Diversified Metal Fabricators Service Bulletin SB 2051

Title	RW-1019 Long Arm Slots Issues for 2005-2008 Ford F-450/550's
Document No.	SB 2051
Issue Date	8/13/07 (WAK)
Units Affected	2005-2008 Ford F-450s and F-550s
Purpose	This service bulletin addresses a product improvement for RW-1019 front railgear on model year 2005 and newer Ford F-450's and F-550's.

Fig. 1: New Longarms

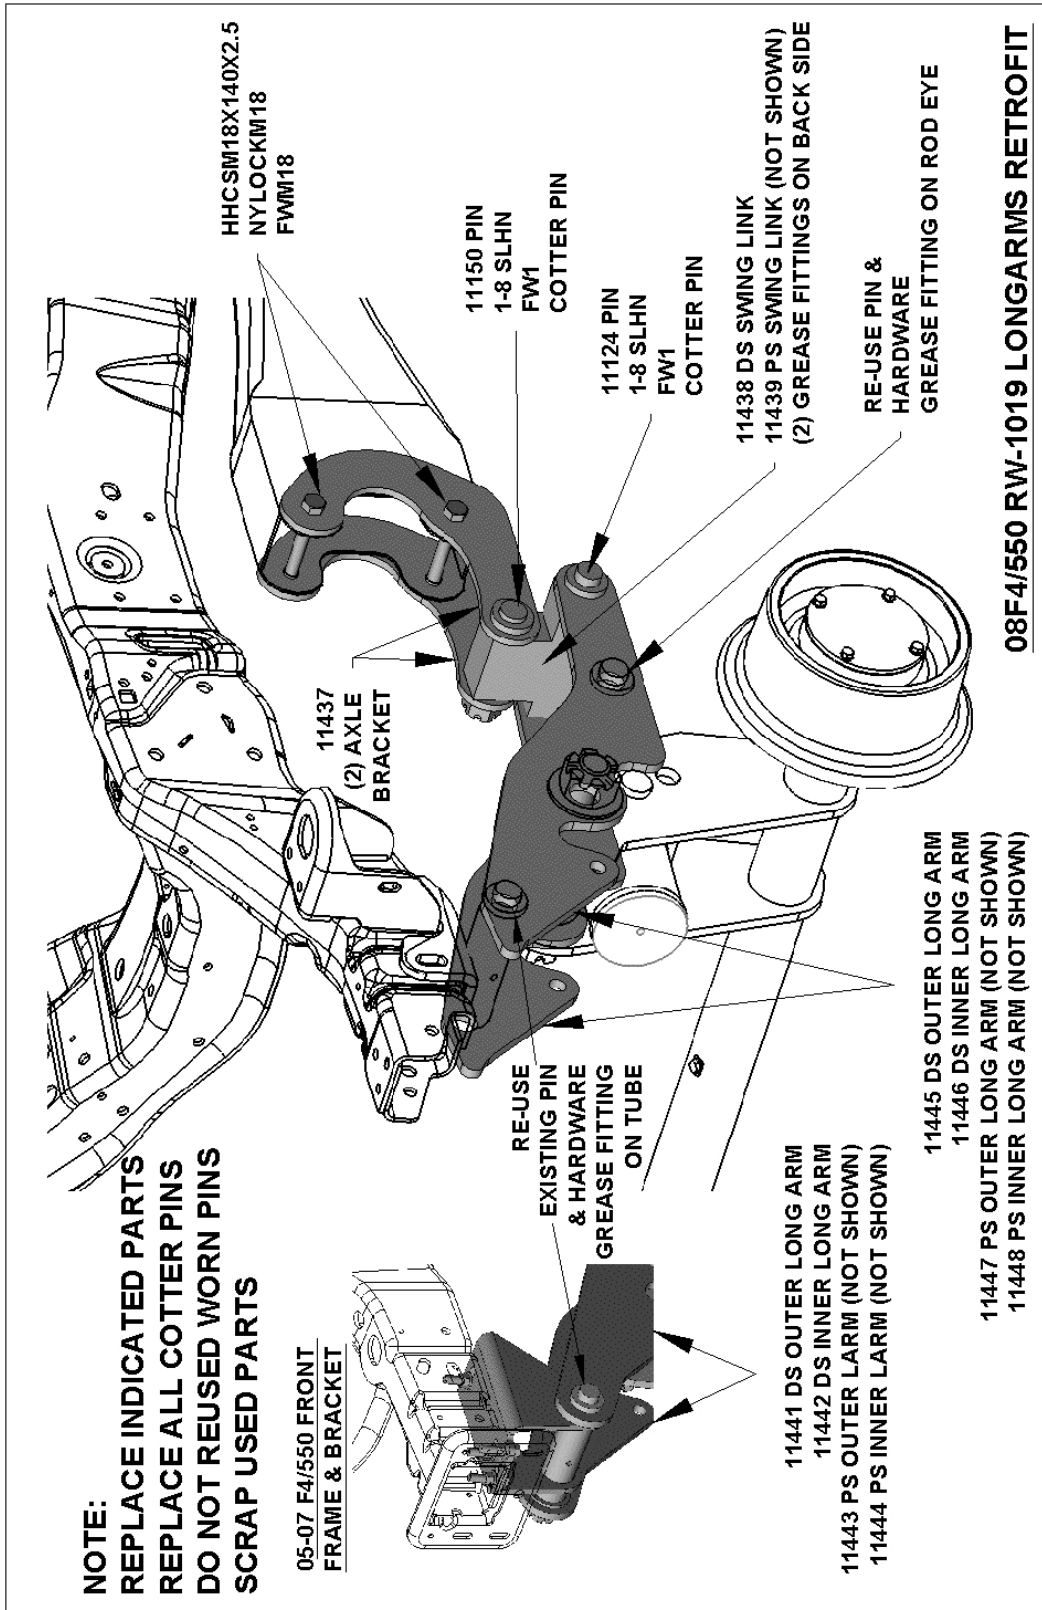
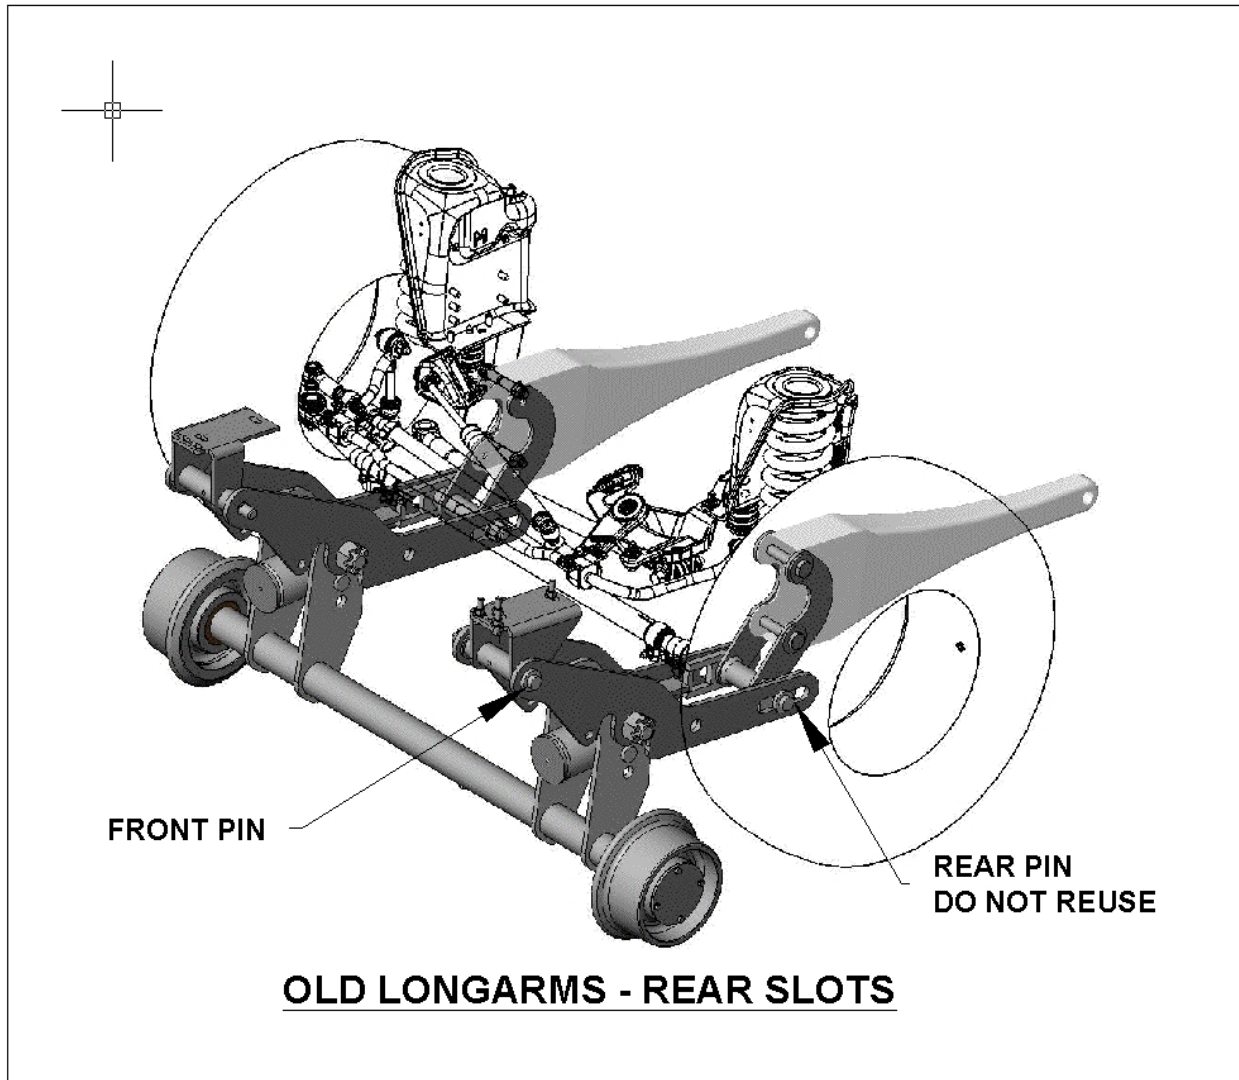
In order to improve resistance to wear on pins, RW-1019 railgear for '05-'08 Ford F4/550 has been re-designed. Units with any configuration of slots (front, rear, with or without slidebars) should be converted to the current configuration. The current configuration uses a swinging link to replace the pin/slot.

- Longarms with front slots
- Longarms with rear slots with or without guide rails & slide bars (see Fig. 1)

These arms will be replaced with new longarms and will be provided with new rear pins, washers and nuts. The axle brackets rear pins will also be replaced.

The only difference between the '05-'07 kits and the '08 kits are the front end of the long arm and the front bracket due to differences in the frame ends. The front bracket is re-used as is.
